DEVELOPMENT APPLICATION

APPLICATION NUMBER:	PLN-25-350
PROPOSED DEVELOPMENT:	Demolition and construction of four Multiple Dwellings
LOCATION:	36 Bowden Street Glenorchy 38 Bowden Street Glenorchy
APPLICANT:	Pinnacle Drafting & Design
ADVERTISING START DATE:	09/01/2026
ADVERTISING EXPIRY DATE:	23/01/2026

In response to your correspondence dated 15/12/2025
I have addressed your requests as follows:

East Elevation

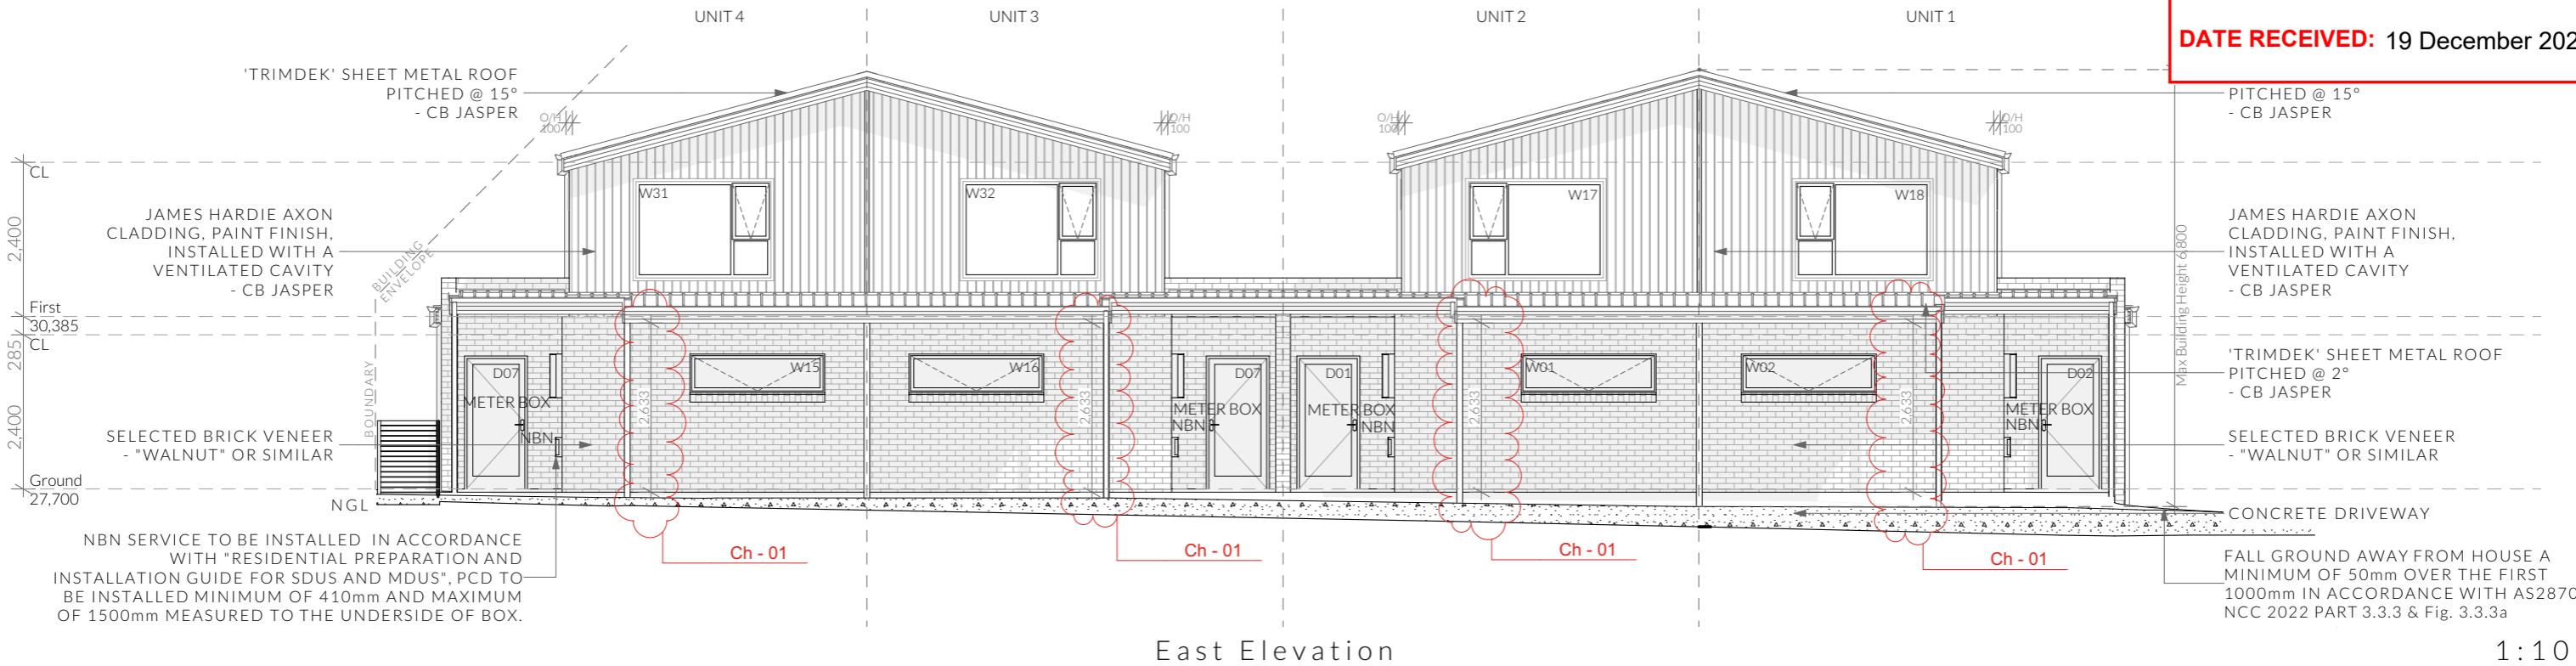
Turn paths entering and existing all car spaces using B99 template in accordance with Tasmanian Standard Drawing.

(vi) Vertical Clearances of Carports are shown on the East Elevation on sheet A.07 exceeding min clearance of 2100.

Scale: @A3	Revision: DA-01	Pg. No: A.04	Approved by: SH

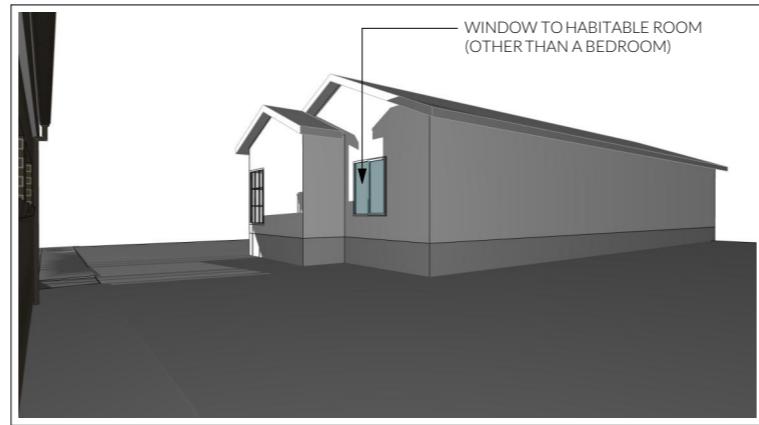
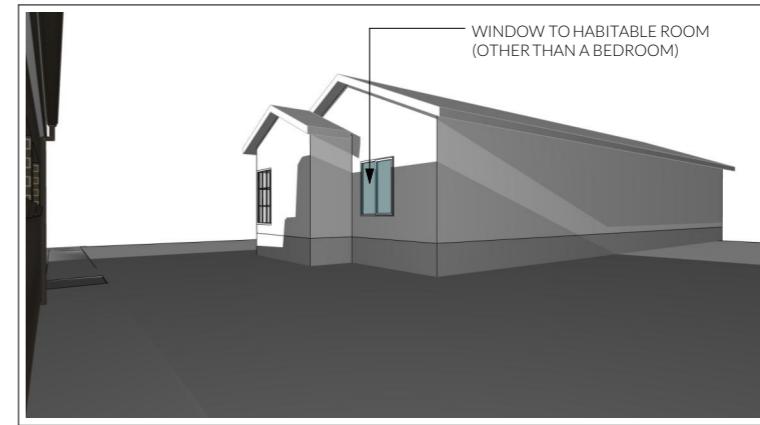
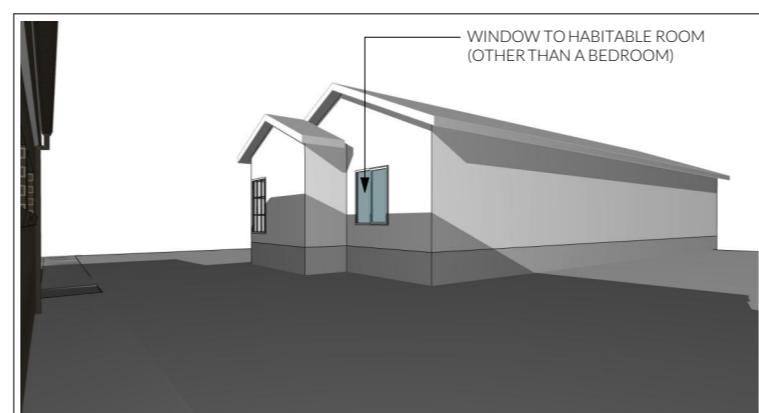
ITEM	COUNCIL REQUEST	DEVELOPMENT RESPONSE
1	<p><i>Clause 9.4.2 - A1, Setbacks and building envelope for all dwellings</i></p> <p>The submitted plans show the building and works outside the building envelope near the south-west boundary (adjacent 2 Stansall Street). Please note that reliance on the performance criteria would include shadow diagrams.</p> <p>Please demonstrate that the proposal complies with acceptable solutions A3 or satisfies performance criteria P3 of Clause 9.4.2 Setbacks and building envelope for all dwellings, Tasmanian Planning Scheme - Glenorchy.</p>	<p>The proposal is shown within the building envelope shown on sheets A.06 and A.07, however is within 1500 of a side boundary and longer than 9m triggering a discretion under clause 9.4.2.</p> <p>Shadow Diagrams have been provided on sheets A.02, A.03 & A.04 and address the performance criteria of Clause 9.4.2 as follows:</p> <p>a(i) Sheets A.03 & A.04 Show the reduction of sunlight to habitable rooms other than bedrooms of 2 Stansall Street. Sheet A.03 (View 1) Shows minor overshadowing for 2 hours of the 6 required by the scheme of the living room window to the East, while Sheet A.04 shows overshadowing also for 2 hours of the 6 required by the scheme to the Kitchen window to the North East. Based on the scope of the 6 hours in the winter solstice required by the scheme, this amount of overshadowing is not unreasonable.</p> <p>a(ii) Sheets A.02 and A.03 show the extent of overshadowing to the possible private open space of 2 Stansall Street, demonstrating that for at least 3 hours out of the 6</p>

a(iv) Visual bulk and scale images are demonstrated on sheet A.04 from both 2 Stansall Street and 40 Bowden Street. The Bulk and scale have been kept as minimal as possible with the upper floor reduced in size in comparison with the lower floor complimentary to surrounding scale in the area. This reduces overshadowing and reduces loss of privacy.
